Study of vehicle BCI test for UN R10

31th, Oct. 2017

Japan Automobile Manufacturers Association, Inc.

1.3. Alternative test methods

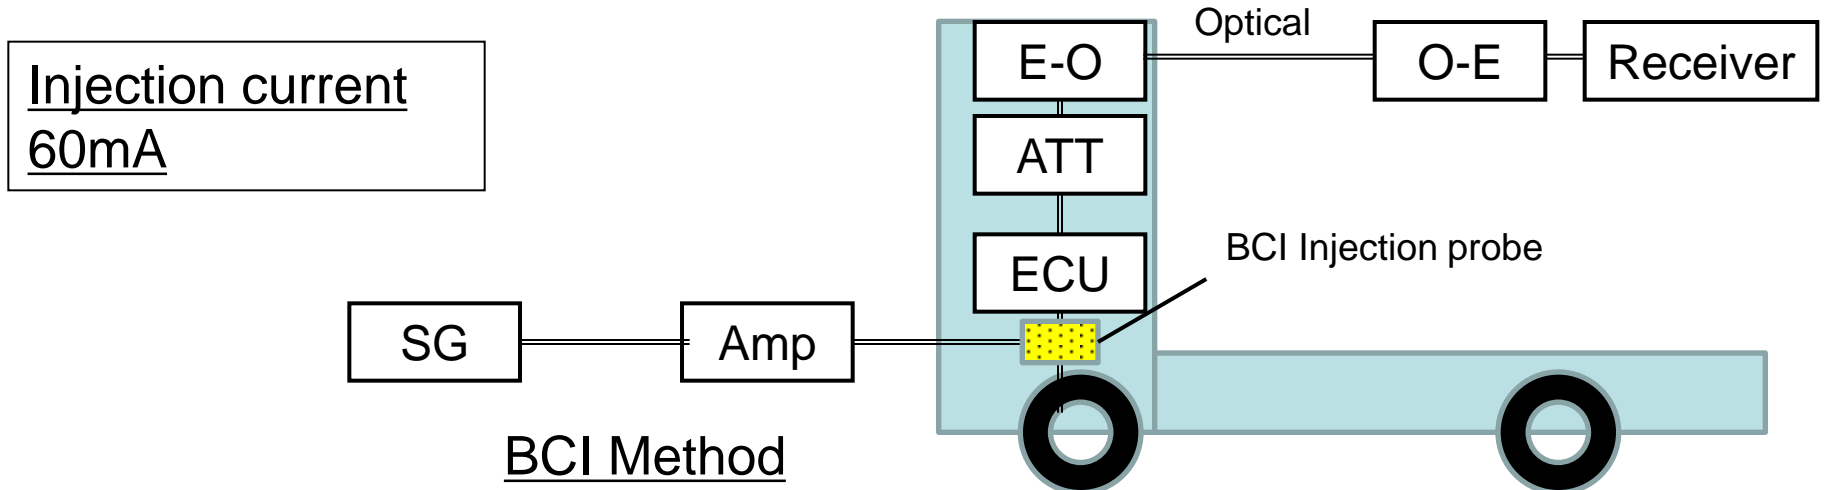
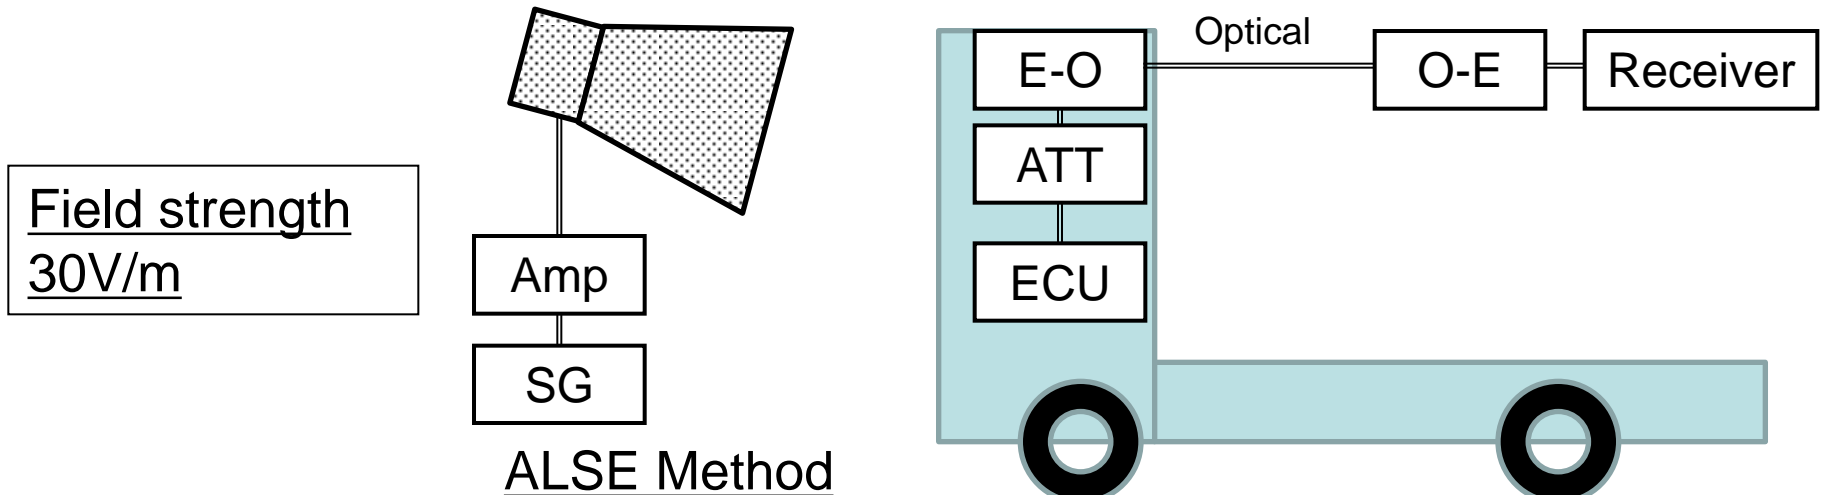
~~If a vehicle is longer than 12 m and/or wider than 2.60 m and/or higher than 4.00 m,~~ BCI (bulk current injection) method according to ISO 11451-4 shall **can** be used in the frequency range 20 to 2,000 MHz with levels defined in paragraph 6.8.2.1. of this Regulation.
